Technical Service Information

ZF 5HP-24

SLIPPING OR NO FORWARD ENGAGEMENT

Figure 1

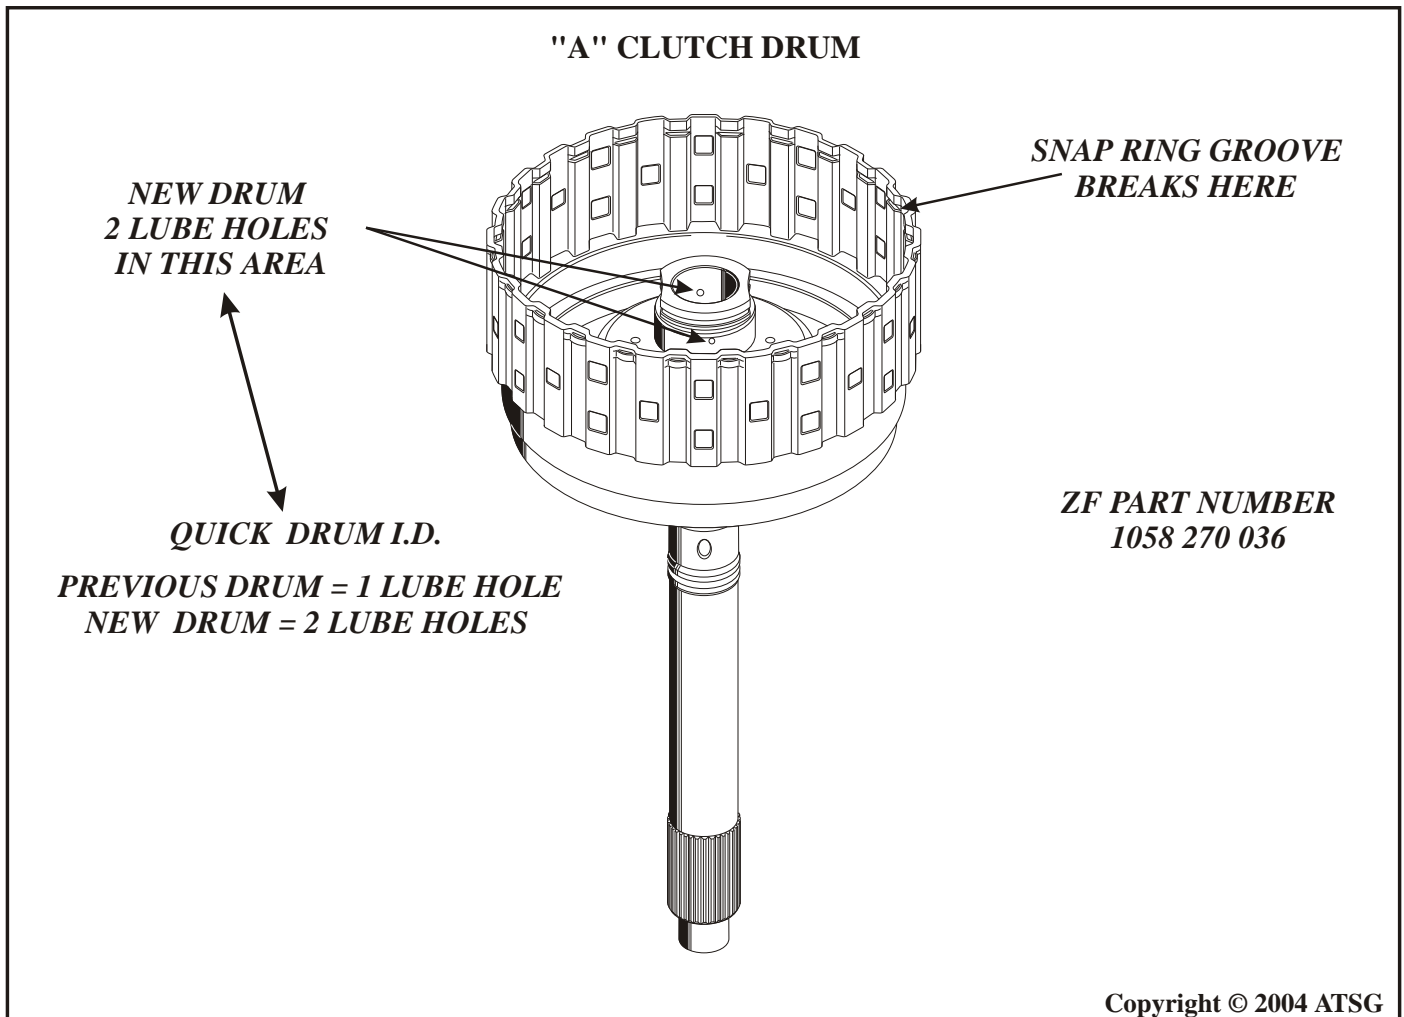
COMPLAINT: Vehicles equipped with the ZF 5HP-24 transmission may exhibit a Slipping or no Forward engagement.

CAUSE: The cause may be, a broken snap ring groove in the "A" Clutch Drum allowing the "A" Clutch to slip, as shown in Figure 1.

CORRECTION: Replace the "A" Clutch Drum with the updated drum available from ZF.

A CLUTCH DRUM (ZF part number).....1058 270 036
